PROJECT TITLE
 NEW SITE DUMPSTER ENCLOSURE
 ATLANTIC PLAZA
 6828 WEST ATLANTIC BLVD
 MARGATE, FLORIDA 33063

SHEET TITLE
 LANDSCAPE PLAN

REVISIONS	No.	DATE	DESCRIPTION
	1	8-11-09	BLDG DEPT COMMENTS
	2	9-29-09	REVIEW COMMENTS
	3	10-29-09	WIN COMMENTS
	4	9-15-10	OWNER CHANGE

SHEET
 LS-1.0
 4 OF 6

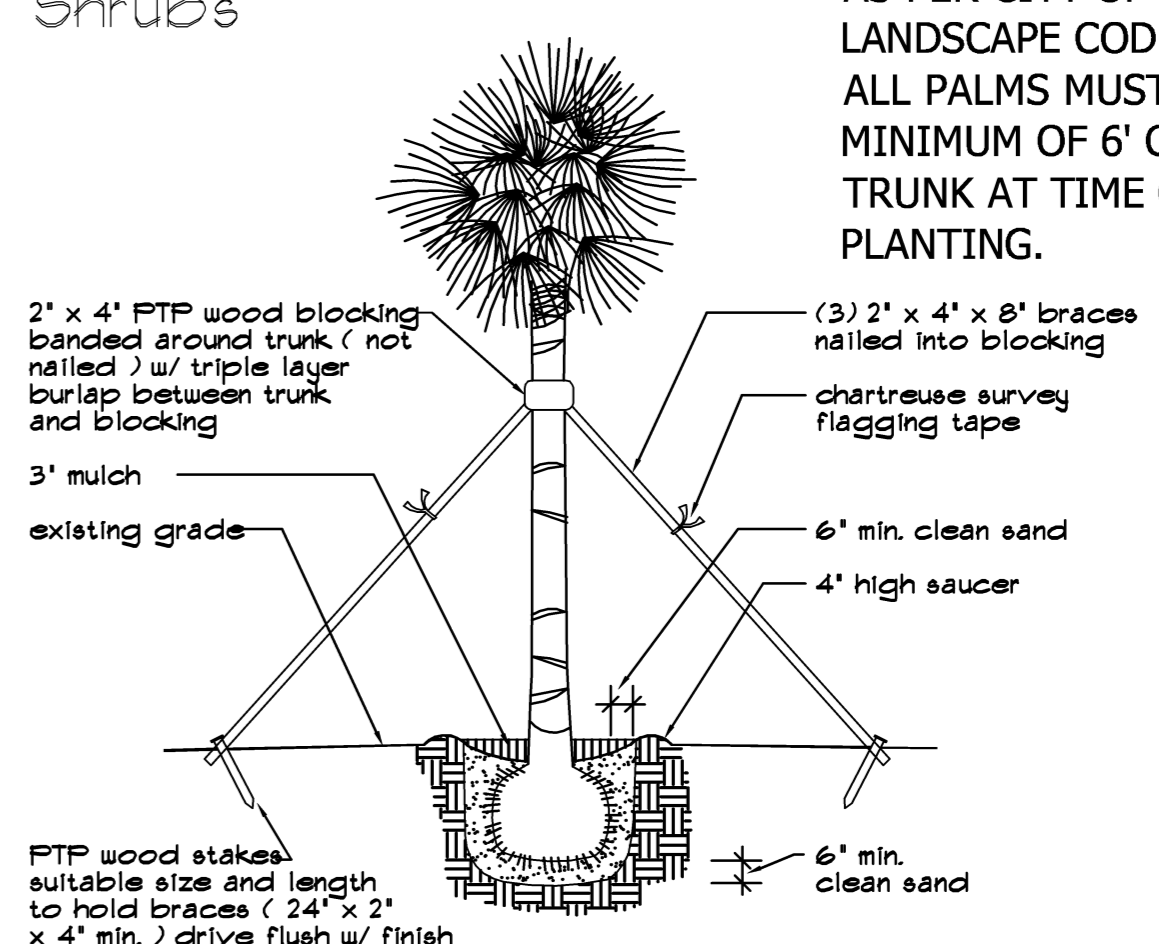
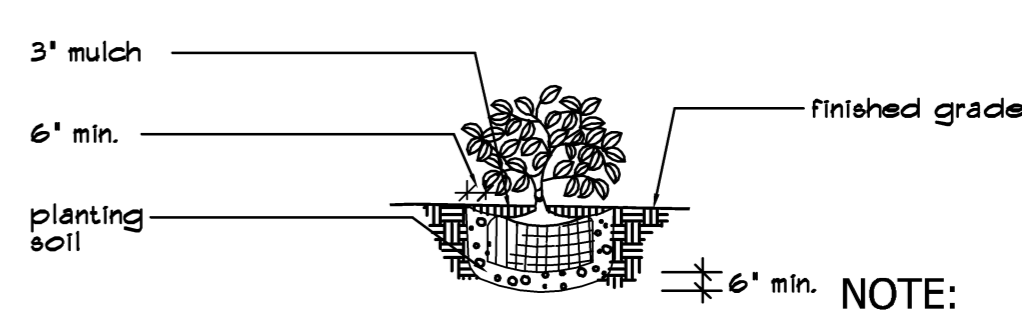
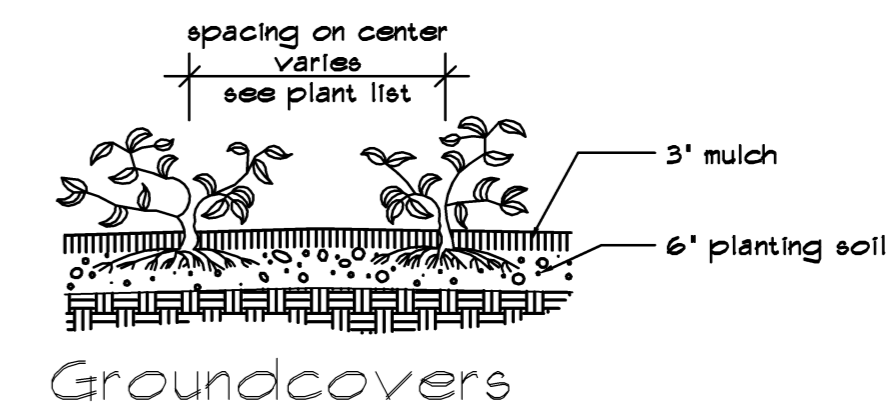
NOTE:
 (7) ADDITIONAL TREES REQUIRED AS PER TOWN OF MARGATE'S BUILDING DEPARTMENT REVIEW/ COMMENT.
 AS PER THE TOWN OF MARGATE'S ZONING CODE, SEC. 12 1/2-5, (3) PALMS CAN BE SUBSTITUTED PER TREE.

(21) NEW PALMS ARE PROPOSED.
 (9) SABAL PALMS AND
 (12) CHRISTMAS PALMS TO MATCH EXISTING PALMS.

ADDITIONALLY:
 (2) EXISTING CABBAGE PALMS WILL BE REPLACED WITH (2) NEW SABAL PALMS IN ORDER TO MATCH LANDSCAPE ISLANDS.

(1) EXISTING CABBAGE PALM WILL BE REPLACED WITH A TRIPLE ALEXANDER PALM.

(8) NEW DESERT CASSIAS WILL BE ADDED TO THE SWALE AREA ALONG NW 69TH AVENUE IN ORDER TO ENHANCE THE EXISTING LANDSCAPING.

NOTE:
 EXISTING IRRIGATION SPRINKLER SYSTEM TO BE RECONFIGURED TO INCLUDE DUMPSTER ENCLOSURE LANDSCAPING. G.C. TO SUBMIT SHOP DRAWINGS OF REVISED IRRIGATION TO THE CITY OF MARGATE FOR REVIEW AND APPROVAL.
